Summary of Items Discussed in 3/2016 APSEC Discussion Forum on 27 May 2016

b. FS Code Clause C9.7 - 6m Separation

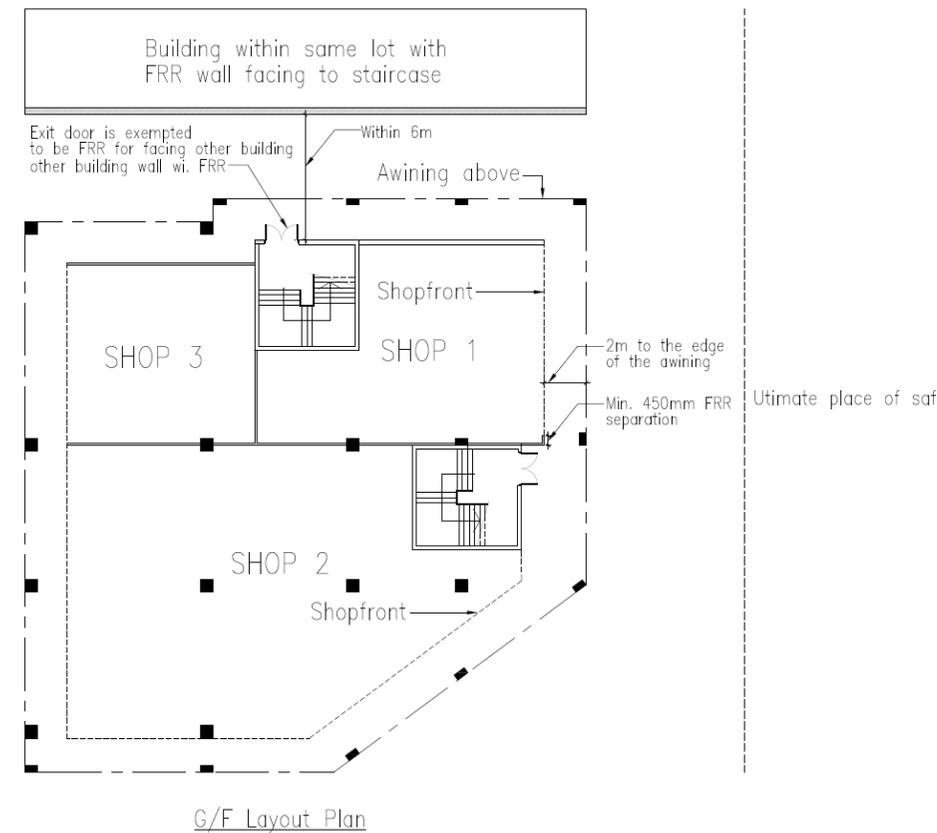
When G/F exit of required staircase facing to and within 6m of other building within the same site, please advise if G/F FRR door of required staircase could be exempted from Clause C9.7 provided that there is FRR wall by other building within 6m from the discharge point of the required staircase.

- b. Clause C9.7 (d) would be applicable and a fire-rated door would be required to protect the discharge point at ground storey. Diagram C2 Example (a) was relevant.
- c. Compliance with Subsections B7 and B8 and Table B2 of the FS Code should be checked on room, storey as well as compartment basis.
- d. The understanding on the part of the covered walkway was correct provided that the exit route at the temporary place of safety comply with Subsection C9 and Clause C12.4. The floor of the temporary place of safety should also have an FRR of not less than that of the storey below. Clause B5.3 and Diagram B1 were also relevant.

c. Determination of the Number and Width of Exit Doors/Exit Route

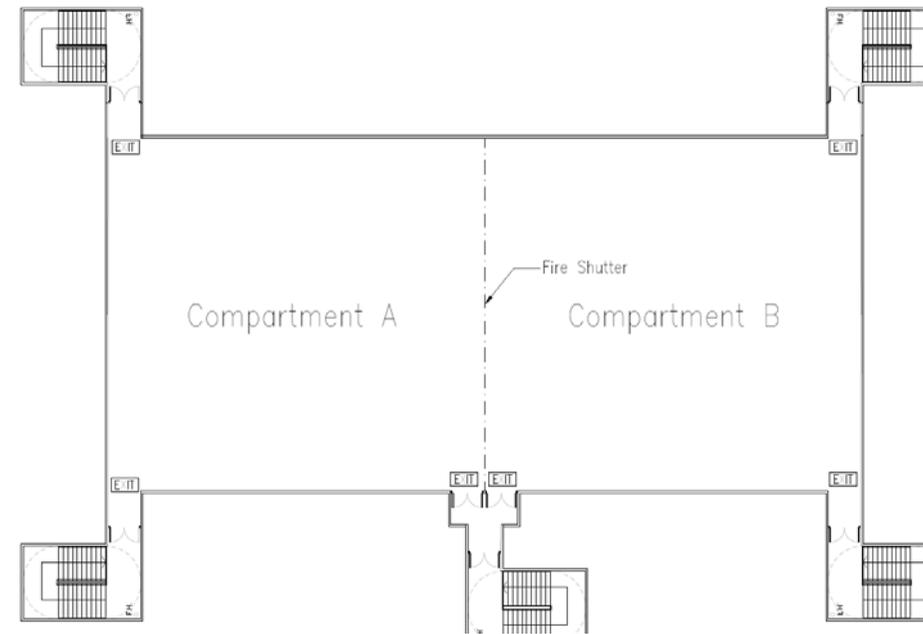
When two compartments "A" and "B" are separated by the fire shutter with by-pass lobby connected for communication, number and width of exit doors and exit routes could be determined on room and compartment basis rather than storey basis provided that:

- (1) exit of compartment without relying on exit door/exit route of other compartments; and
- (2) capacity of whole storey do not exceed 3,000 people

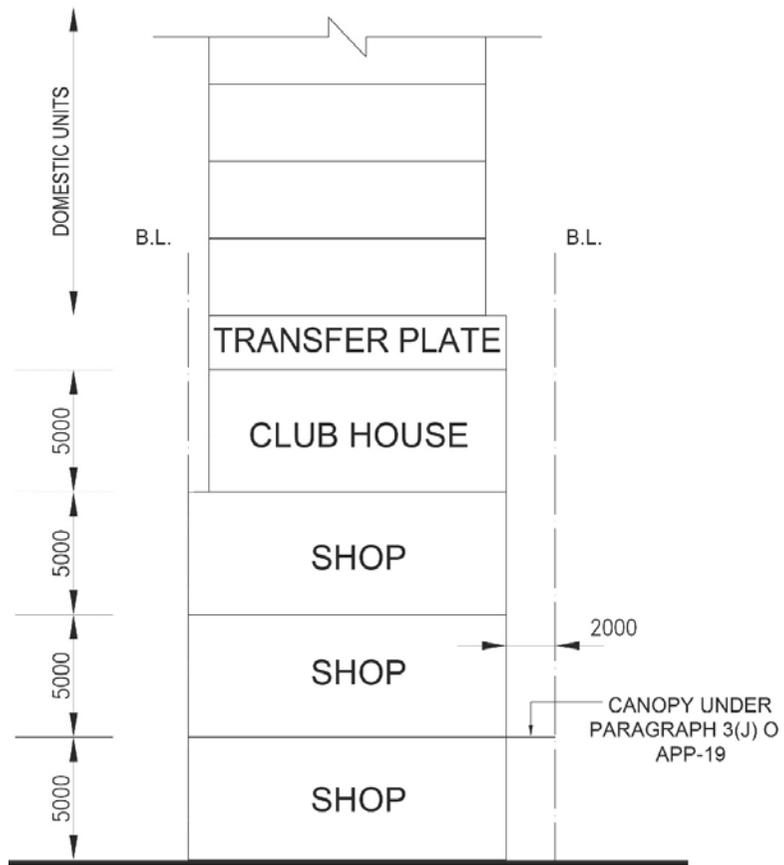
According to para. 3(j) of PNAP APP-19, canopies within the site boundary projecting not more than 2m over the entrance to a building need not be counted for SC and plot ratio (P.R.). Please clarify if such a canopy may also be applied to a G/F retail shop, which is set back from the site boundary.

22.	<p><u>Protection of Public/Residents around Buildings</u></p> <p>(a) Canopies under para. 3(j) of PNAP APP-19</p>	<p>(a) Para. 6 of PNAP APP-19 described the principle that areas covered by projecting features forming shelters capable of functional use should be included in GFA calculations even the concerned width to clear height ratio was not less than 1:8. Only canopies within site projecting not more than 2m over an entrance of a building could be disregarded from SC and GFA calculations. Canopies over the shopfront or the entrance of a retail shop should be included in SC and GFA calculations. However, special circumstances demonstrating public interest or innovative designs which were unlikely to be abused could always be favourably considered on case merits.</p>

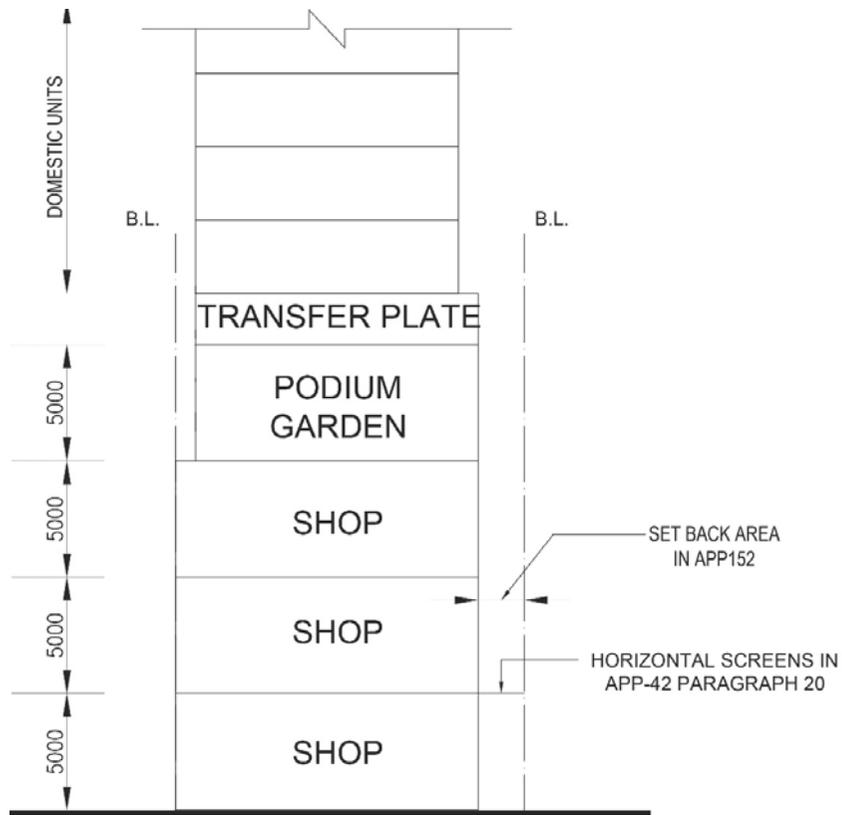
According to para.8(a) of PNAP APP152, a canopy that complies with Reg.10 of the B(P)R may be permitted. Please clarify whether horizontal screens as mentioned in PNAP APP 42 para.20 should also be allowed in these set-back areas.

<p>According to para. 20 of PNAP APP-42, horizontal screens may be permitted in any open areas frequently used by occupants at ground floor or podium floor; or roof garden/ play areas at podium floor around the perimeter of a domestic tower (apparently within site boundary). As it does not specify the use of the building at G/F, so we understand that the use as shop at G/F warrants permission to have such horizontal screen installed.</p> <p>However, in the Chinese version, it is stated that “在位於住用樓宇的地面層及平台樓層經常被使用的露天地方或位於天台花園/平台塔樓周邊的遊戲場地.....”</p> <p>Hence, it apparently qualifies that the open areas at ground floor or podium floor should only be applied to domestic buildings. The discrepancy is noted, when compared with the English Version. Please clarify which one we should follow.</p> <p>(c) Set back requirement under PNAP APP-152</p>	<p>(c) Para. 8 of PNAP APP-152 specified that the setback area should be without any permanent building structures other than landscaped features, perforated balustrades, perforated boundary walls and structural columns. Minor projecting features and signboard projecting not more than 600mm from the external walls and at a clear height of not less than 2.5m above the street level; and single storey footbridges <u>across</u> the setback area might also be permitted. In this connection, a horizontal screen that could meet the above requirements might be permitted within the building setback area under PNAP APP-152.</p>
